ROCK SPRING MASTER PLAN

Planning Board Worksession #6: March 16, 2017

Rock Spring: Edits to Planning Board Draft

Rock Spring Master Plan: Edits to Planning Board Draft

Proposed Zoning Planning Board Draft

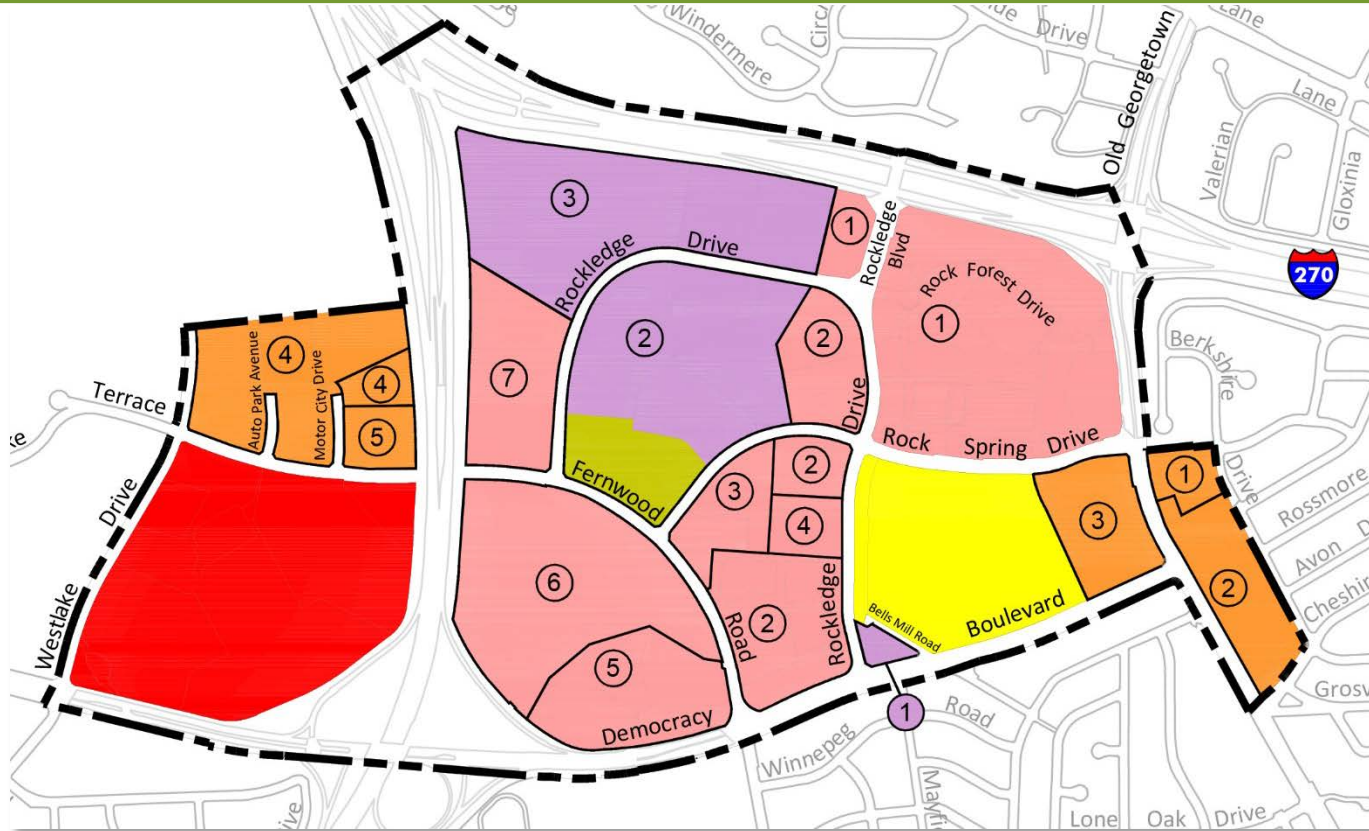
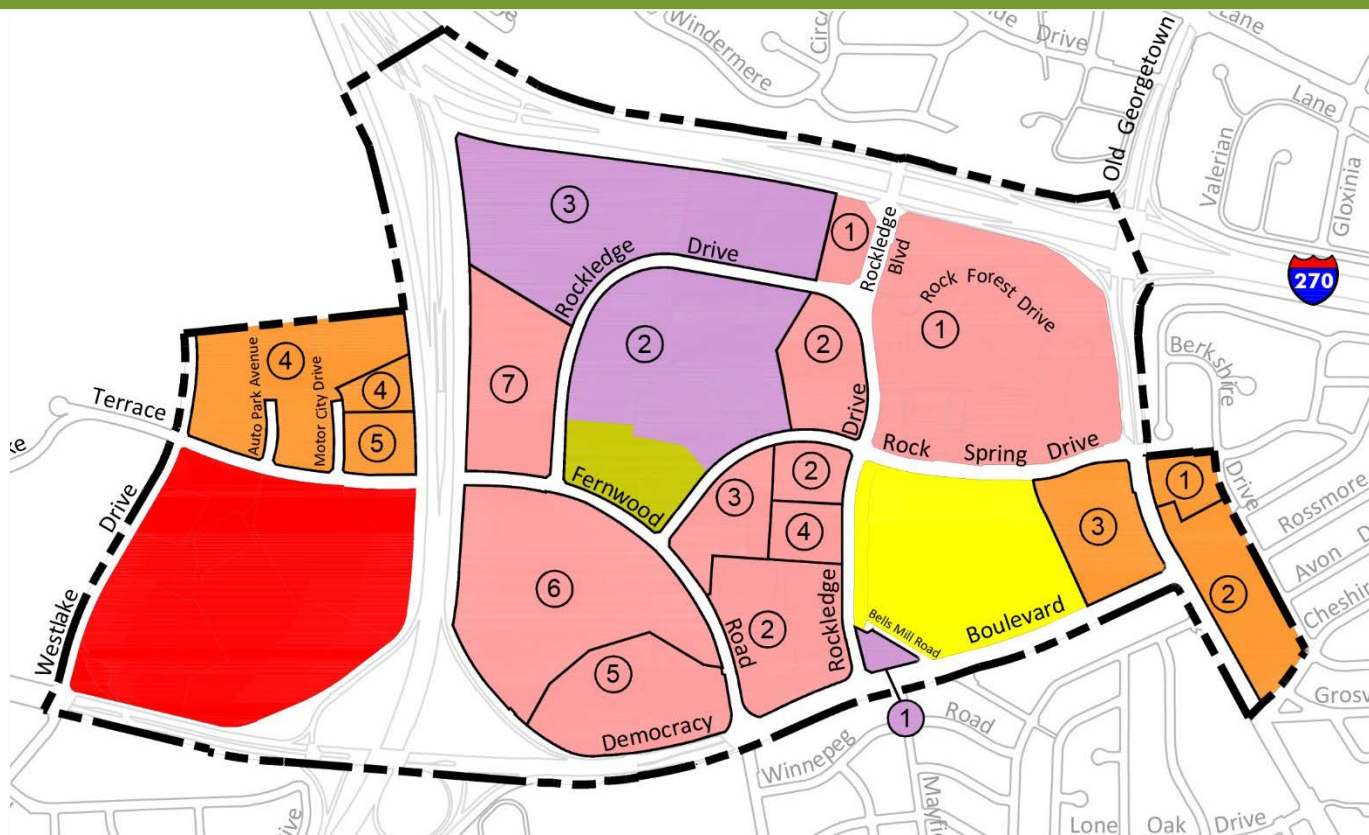
For properties along the central spine, the Plan recommends that the EOF Zone be replaced with the CR Zone. The Plan recommends a consistent zoning approach for these properties, as follows: an overall FAR of 1.5, commercial FAR of the same amount that the property has under the EOF Zone, and residential FAR of 0.75. Building heights along I-270 and the spur are somewhat higher than those along the central spine. Zoning recommendations for specific properties are as follows:

Democracy Associates (6901 Rockledge Drive): CR-1.5, C-1.25, R-0.75, H-150

Marriott International Headquarters (10400 Fernwood Road): CR-1.5, C-0.75, R-0.75, H-150

Democracy Plaza (6701 and 6707 Democracy Boulevard) and Marriott Suites Hotel (6711 Democracy Boulevard): CR-1.5, C-1.0, R-0.75, H-150

Rockledge Executive Plaza (6600 and 6610 Rockledge Drive): CR-1.5, C-1.0, R-0.75, H-100

Rock Spring Plaza (6550 and 6560 Rock Spring Drive): CR-1.5, C-1.5, R-0.75, H-100

6430 Rockledge Drive: CR-1.5, C-1.25, R-0.75, H-100

6410, 6420, 6500 Rockledge Drive and 10215 Fernwood Road: CR-1.5, C-1.0, R-0.75, H-100

Democracy Center 6901 Rockledge Drive (#1)

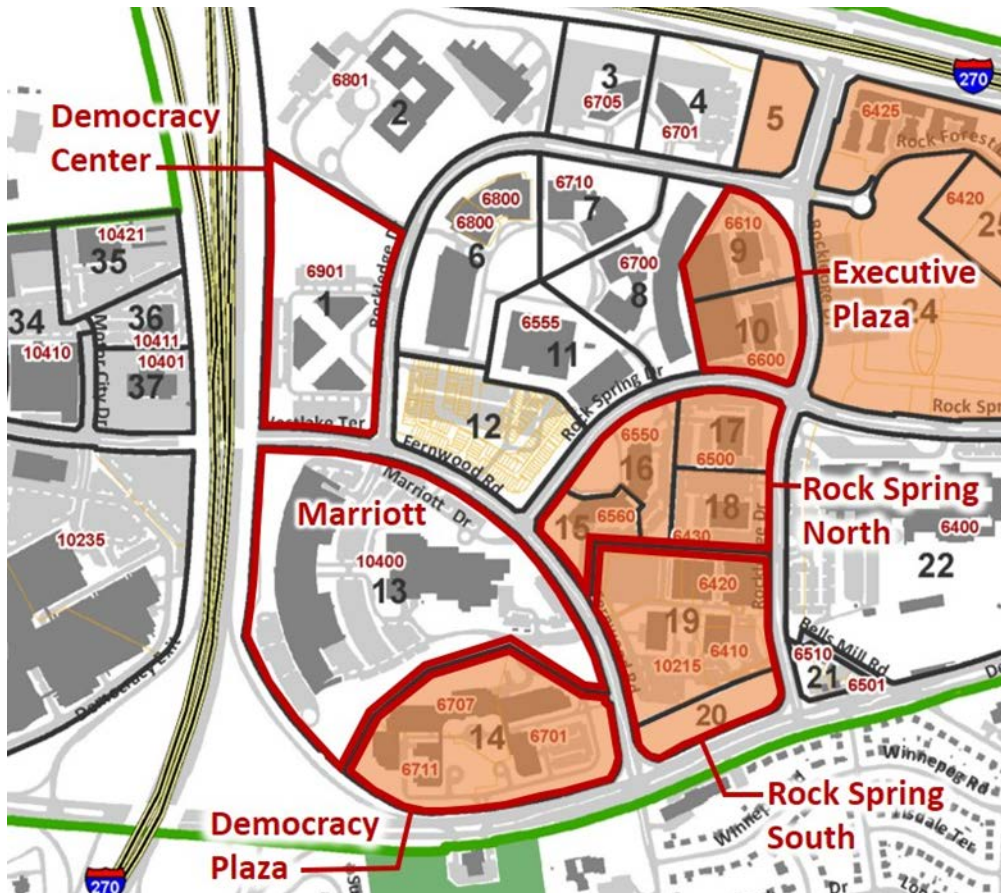
Owner's Request: CR-2.0, C-1.25, R-1.25, H-200 (conditioned on open space being dedicated as parkland)

Revised Zoning: **CR-1.5, C-1.25, R-0.75, H-150** Potential DUs: 400

Rock Spring Master Plan: Marriott Site

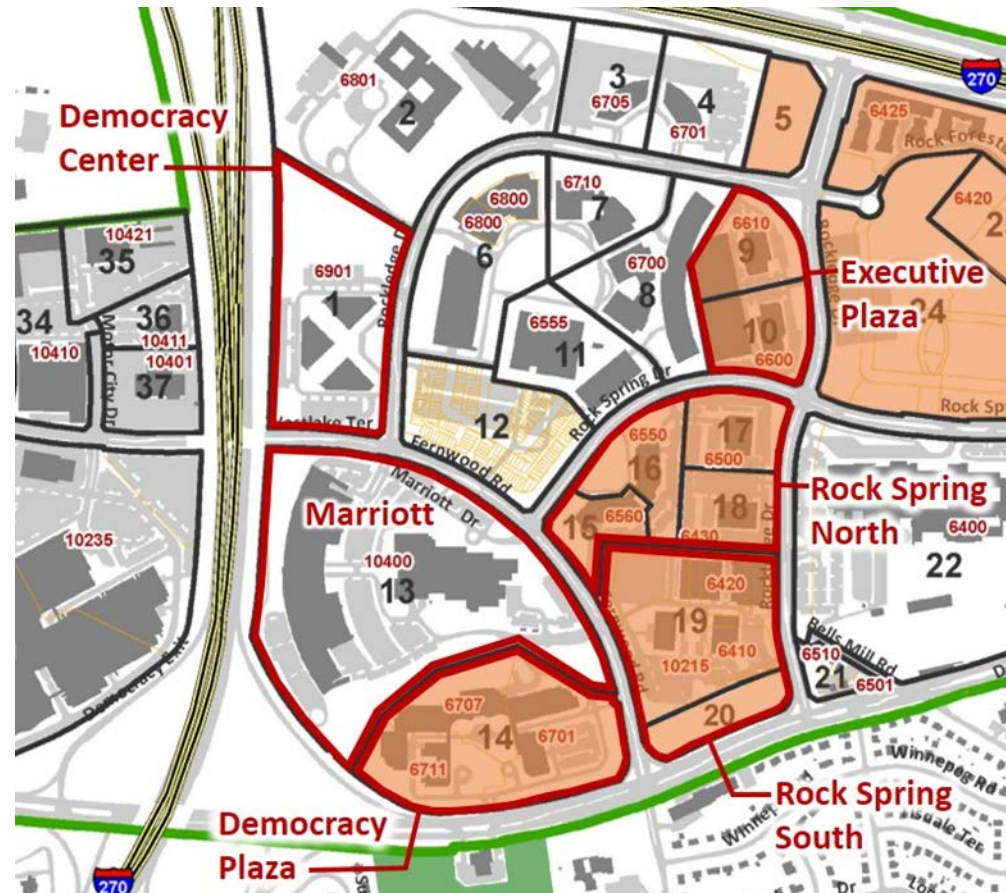
Owner's Request: CR-1.5, C-1.5, R-1.0, H-150 (or Modified EOF zone)

Revised Request: **CR-1.5, C-0.75, R-0.75, H-150***
